WORKSHOP AGENDA

Planning Commission

October 14, 2025 @ 5:30 PM

Item #: 3. Site Plan - Dous Retail Center - Building totaling 4,200 Square Feet on 1.28 Acres. Requested by Chet Rhodes. Property located at 5130 Murfreesboro Road (Tax Map 15M, Group A, Parcel 1). C-2 (Highway Service) Zoning District. Property owned by TN Group Properties, LLC.

UTILITY PLAN

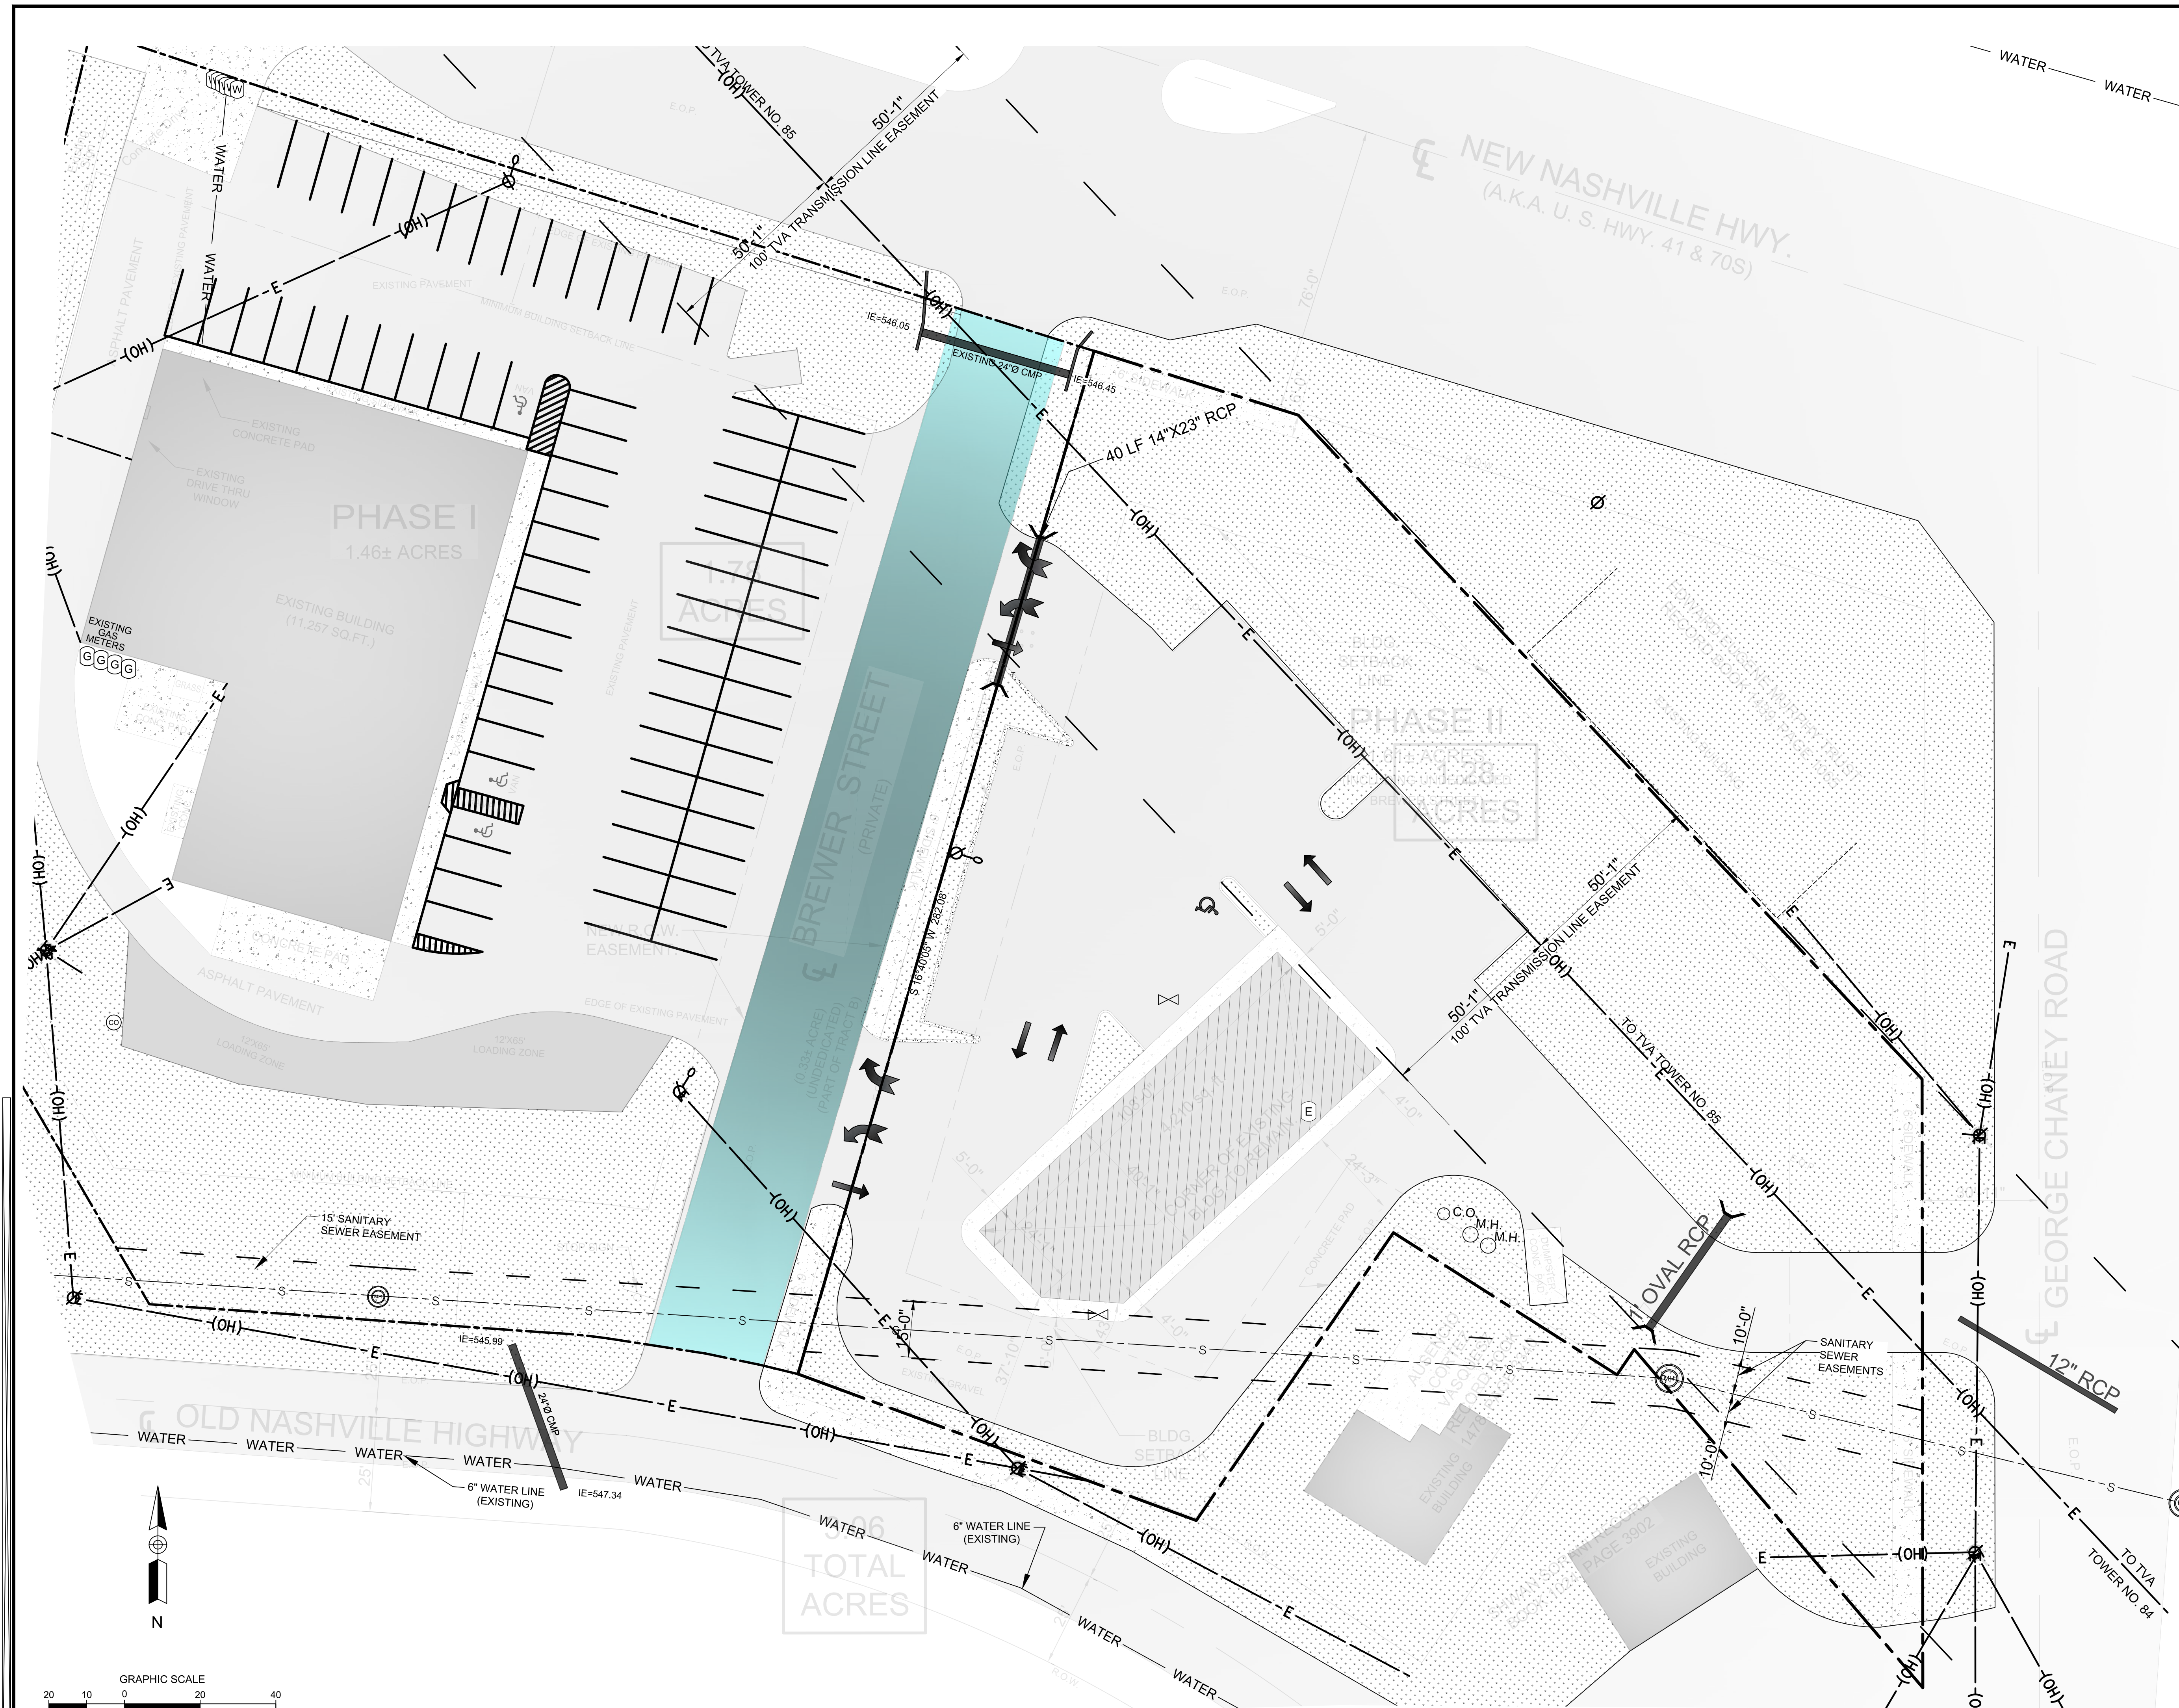
1. Sht C4.0 - Show existing 8"DIP public waterline in south side of Murfreesboro Rd.
2. Sht C4.0 - Indicate distance to closest usable public FH, approximately 503 feet from the southwest corner of the property. FHs on north side of Murfreesboro Rd are not usable for this lot.

3. Sht C4.0 - Install new public FH on 8"W on south side of Murfreesboro Rd, approx 10 feet west of existing water meter for 5136 Murfreesboro Rd.
4. Sht C4.0 - Show existing 3/4" water meter for 5136 Murfreesboro Rd, which is approximately 4' north of southern Murfreesboro Rd ROW approximately 40 east of the nwc of the lot.

5. Sht C4.0 - Show how existing water meter plumbs to existing building.
6. Sht C4.0 - Shown water valve at nwc of building is not a water valve it's two pipes sticking out of concrete inside a traffic rated box labeled "water."

8. Sht C4.0 - Show and label existing private sewer cleanout just south of the nec along the back of the building.
9. Sht C4.0 - Show and label existing sewer plumbing to building between building, private cleanout, and public cleanout.

10. Sht C4.0 - Show existing 2" low-pressure, PVC sewer. It is located on the north side of Old Nashville Hwy and discharges to the existing MH in the lot to the west (5104-5124 Murfreesboro Rd).

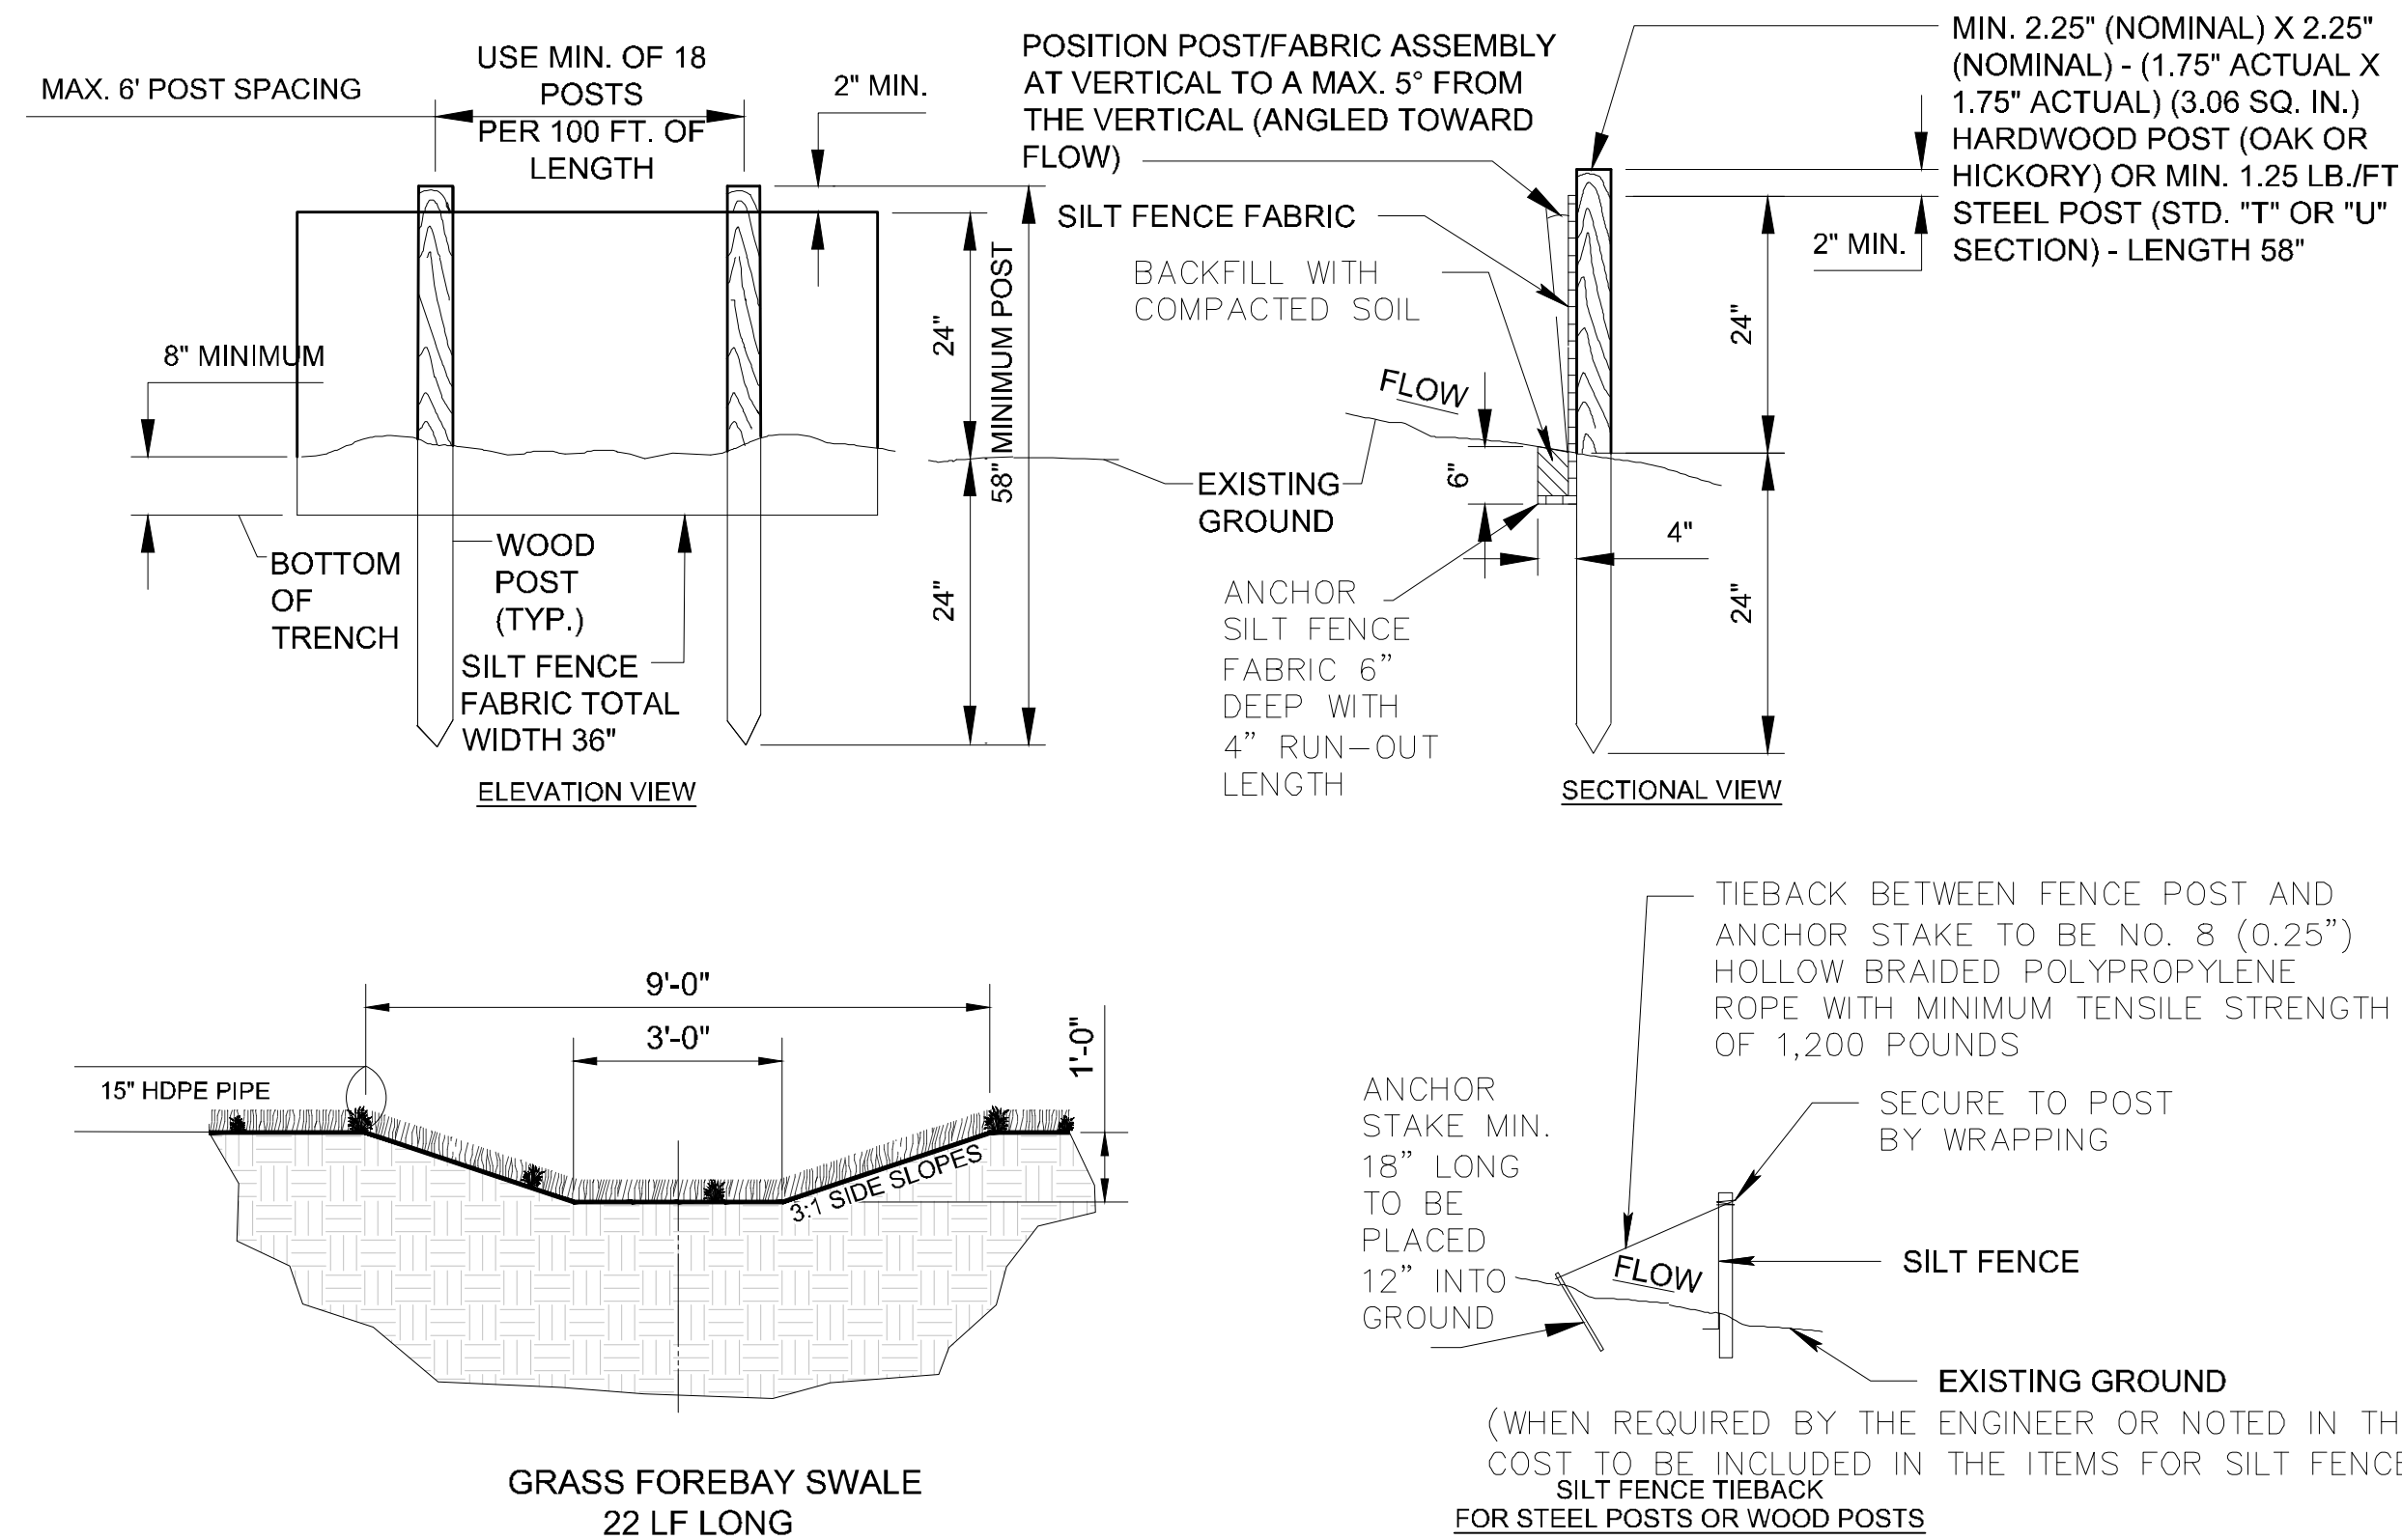
3. (Sheet C-7.2) The detail shown for a "Detention Area and Sediment Basin" will suffice for meeting the Stormwater Management Ordinance water quality requirements. The following must be provided:

- a. Provide stormwater quality calculations for sizing the basin per the Stormwater Management Ordinance. The basin must be sized based on the total area disturbed (proposed building expansion, proposed walk, proposed curb extensions, proposed curb, etc.) regardless of the existing ground surface.

- b. Show the location of the basin on the site and grading plans
 - c. Since this is required as a permanent addition to the site, provide a Longterm Maintenance Agreement (LTMA) and Longterm Maintenance Plan (LTMP) for the basin which must be recorded prior to the certificate of occupancy being issued.

- d. (For information) The city would accept a single riprap baffle in lieu of the three fabric baffles. This would save the owner having to replace the fabric baffles every six months to a year as shown on the plans.
